7th CSPCWG Meeting
23-26 November 2010, Simon's Town, South Africa

Paper for Consideration by CSPCWG

Generic Symbol for Lights in Multicoloured charts

Submitted by:	SWEDEN
Executive Summary:	Sweden would like to bring forward for discussion and further action by the CSPCWG a proposal for a generic light symbol for multicoloured charts. A generic light symbol would be applicable for e.g. Signal Stations and Lighthouses.
Related Documents:	S-4, INT 1
Related Projects:	None known

Image 1 Proposed portrayal of signal station with lights in multicoloured charts.

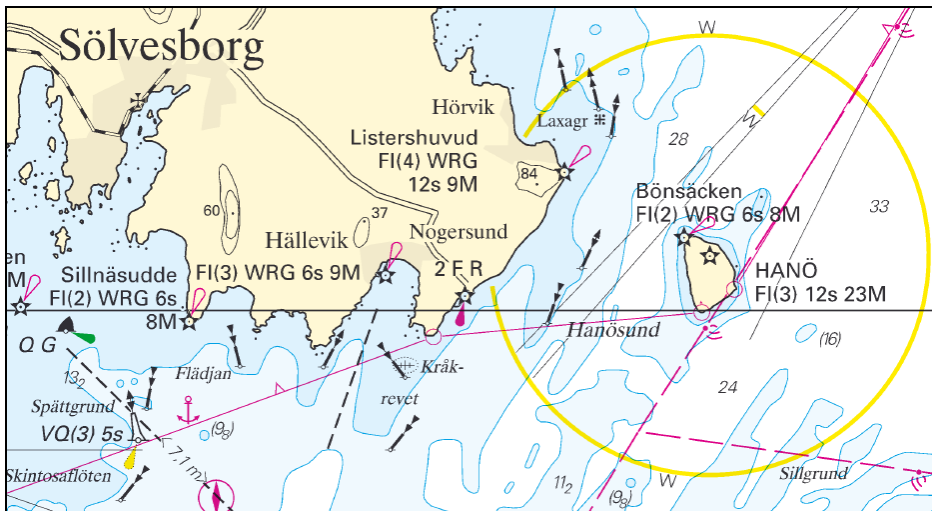
The Swedish Maritime Administration (SMA) has discussed the matter and the issue was also discussed at CSPCWG6. SE proposes that a flare with a magenta outline should be used in these cases. See also images below. Specifically this method should be used when depicting signal stations with lights (B-494) where it is already mentioned in the standard that a standard form of presentation in multicoloured charts is missing. The flare with a magenta outline could also be used in small and medium scale charts when portraying a lighthouse carrying lights with more than one colour (see for example the lighthouse 'Sillnäsudde' below).

A flare with a magenta outline should be used as a generic symbol for lights in small and medium scale charts where it is not useful to portray all lights.

Signal stations communicating visually have declined in importance. They are charted not only for their main role of signalling information and instructions but also as a form of landmark. The signals generally exhibit lights by day and night but may display shapes or flags by day. If required to be charted, the position of the station should be represented by a position circle (B22 - see B-305.1) with a light flare, unless it is known that the signals are not lights. A standard form of presentation has yet to be developed for multicoloured charts (2009). In multicoloured charts a flare with a magenta outline should be used.

Image 3 Example from an ECDIS showing an Overview ENC where a more generic light symbol would be useful.

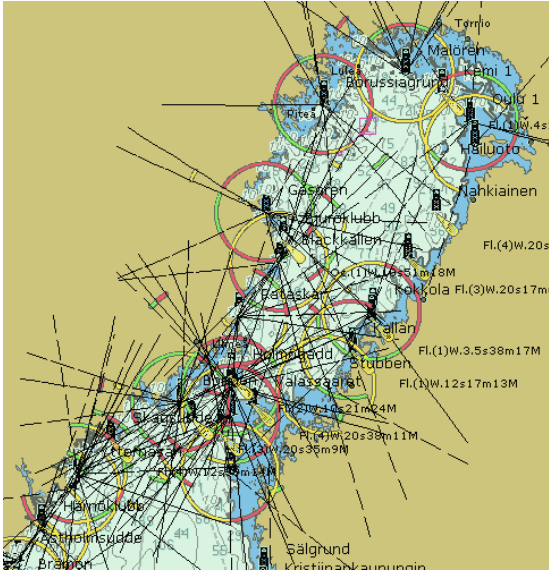
There might be a need for a similar approach in S-57/S-101 where an object has one or more connected lights but you do not wish to show all details for the users. In this case a more generic light symbol would be useful even in ECDIS. An alternative would be to keep all light attributes but include a specific attribute which tells the ECDIS that the lights should not be symbolised. This will give the user the possibility to select the object in order to find more details about the lights.
